Subject	2 - 32 SMITH STREET, SUMMER HILL CONCEPT PLAN APPLICATION
File Ref	P&E>Urban Planning>Strategic>Flour Mills
Prepared by	Con Colot - Senior Strategic Planner & Projects
Reasons	Respond to Department of Planning and Infrastructure
Objective	Response to 2012 Preferred Project Report and Concept Plan application

**2 - 32 SMITH STREET, SUMMER HILL
CONCEPT PLAN APPLICATION**

Figure 3.7

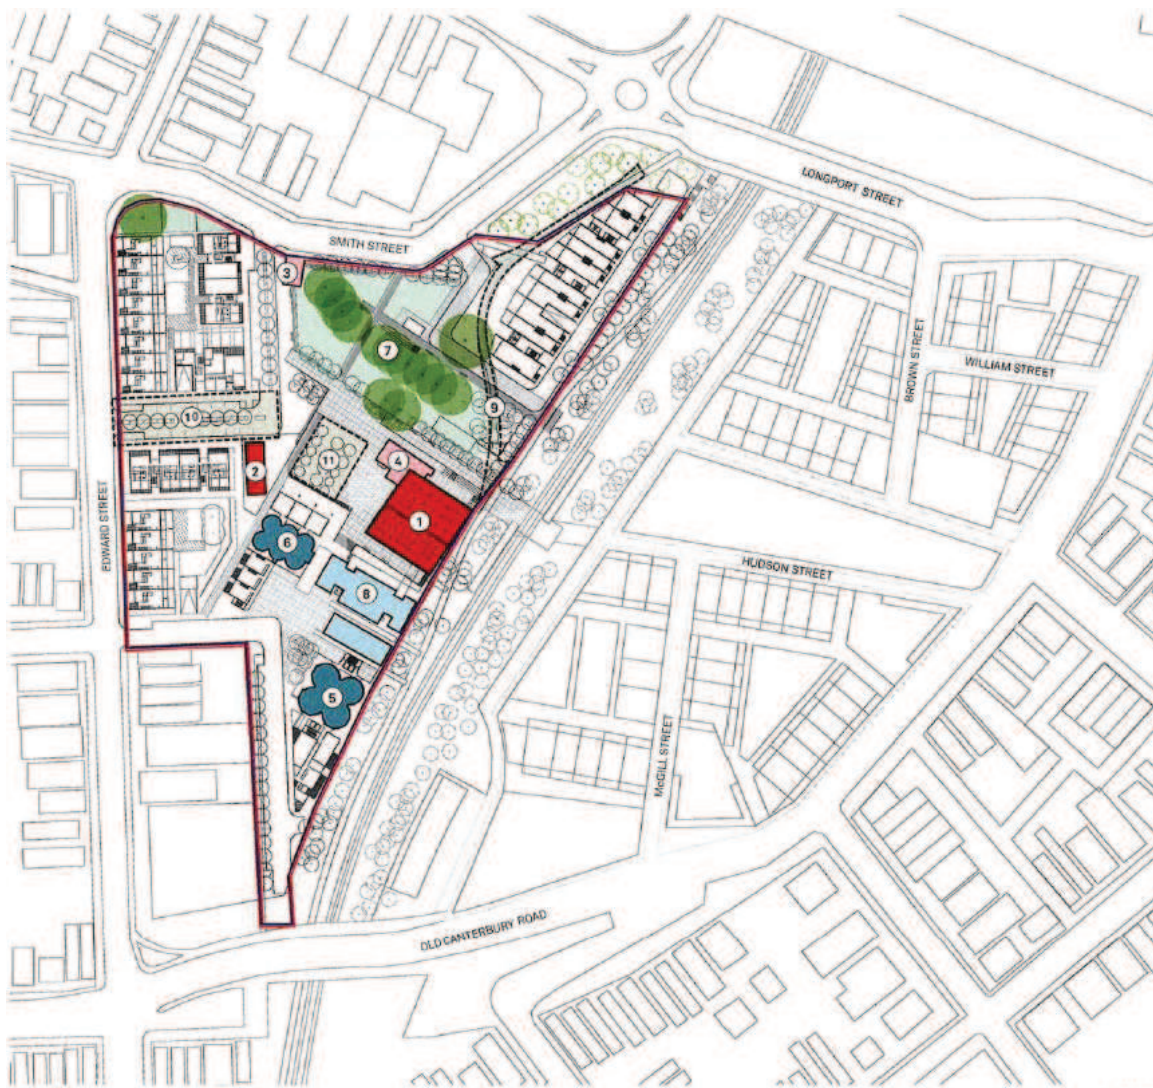
The areas to be retained are only shown on small scale drawings, and include the Mungo Scott building and some silo structures.

For those structures being proposed to be retained and conserved, there is generally an absence of detailed architectural and landscape documentation to give certainty as to what precisely will be conserved, for example:

- there are no adequate, large sized, measured, drawings of the historic buildings.
- there are no adequate large sized, measured, open space curtilages prescribed around the historic buildings.

- noting the previous Flour Mills use, there is no architectural explanation of how this cultural significance, being a combination of architecture and technology (delivery, flour making, dispatch) will be explained/demonstrated in the design for the building and landscape fabric in the proposal.

- the large wooden silos building to the south of the Mungo Scott building is proposed to be demolished on the basis that it is not capable of reuse due to its very fragile structure, e.g. parts of it consist of timber poles and corrugated iron cladding. The applicant states there will be interpretive structures to replace them. However, there are no designs for this, with the required interpretive detail.

If the Concept Plan Application is approved, and the buildings to be retained are denoted as having high heritage significance, it is unclear exactly what this would mean given in the absence of any specific definitions or detailed requirements. Again, due to lack of any architectural detail, any assurances are vague and open ended. For example to what degree can the retained buildings be altered? Any Concept Plan approval should therefore have a requirement that:

The applicant states in page 24 of the PPR that it is not necessary to address any of the above, because the site does not have any heritage listing.

This ignores the current draft listing of the site in the Ashfield LEP and the applicant's own heritage studies which clearly recognise the historic significance of the site.

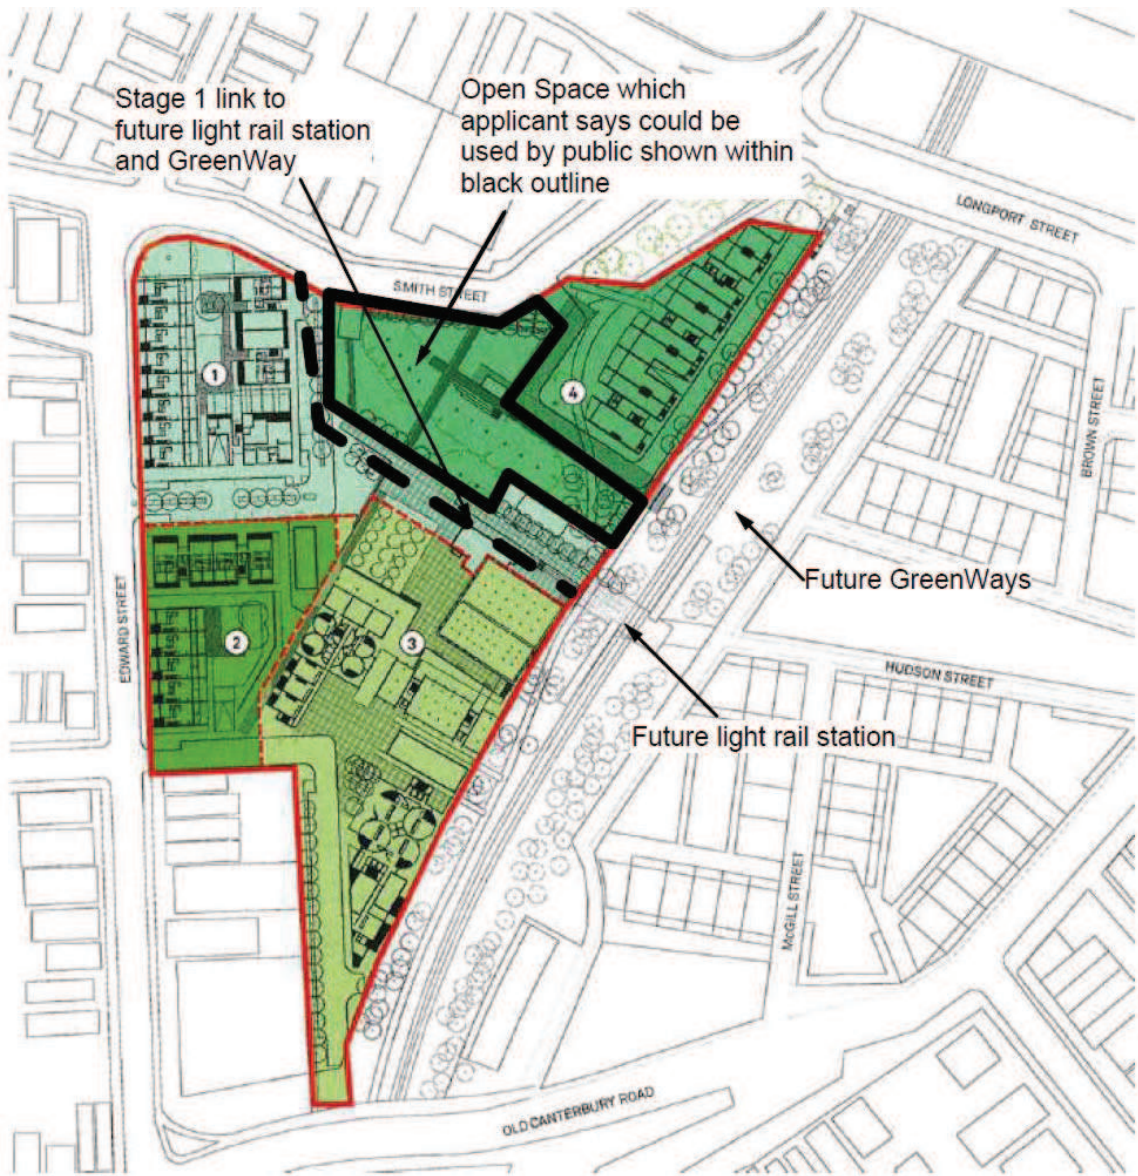
building, between Smith Street and the Hawthorne Canal. This is shown on the site plan on the next page. This area has a unique and rare opportunity for future public open space. This is a relevant matter for consideration at Concept Plan application stage, since the DGRs (Public Domain - Open Space) requires resolution of the matter for linkages to the future light rail station and Greenway, and connectivity to the proposed park to the east of the site within Marrickville (shown in the McGill Street Masterplan). Also, if Council had been in a position to determine new 'uplifted' land use controls for the site in the Ashfield LEP, it is possible that this matter would have been pursued as a normal part of town planning considerations.

It would benefit the local community if the land was made public open space, after its development, and vested into Council ownership. The DOPI should also be requested to assist with this given the access the public open space would provide to the State Government funded and managed future light rail station.

The proposal makes reference to the public having the right to access land within the Flour Mills site but does not specifically detail how this will be achieved. The following statements are included in the Statement of Commitments:

In addition, the proposal includes the provision of buildings within this open space which could be used for commercial/retail purposes. The specific use of these buildings has not been defined or detailed in the proposal. Should Council wish to pursue the dedication of the major communal open space as public open space then these buildings should be removed from the Concept Plan.

The matter of dedication of public open space should therefore be addressed prior to any Concept Plan approval. This should be undertaken by specifying on the plan the location and area of land to be dedicated, and showing on the Staging Pan when it is to be dedicated. This should preferably be developed as part of the first stage of the development so that all subsequent stages of the proposal have access to this space. The dedication of identified public open space should also form part of the Statement of Commitments.

The applicant implicitly states on page 27 that they are not agreeable to putting open space into Council's ownership (i.e. donating land to Council).

The applicant now shows on the Staging Plans (see diagram on following pages) that at Stage 4 there will be provided a large central open space area, implicitly for the use of all residents of the site at the middle part of the site. In the PPR the applicant states it would be willing to allow public (non site resident access), but this is not stated in any adequate detail in the Statement of Commitments.
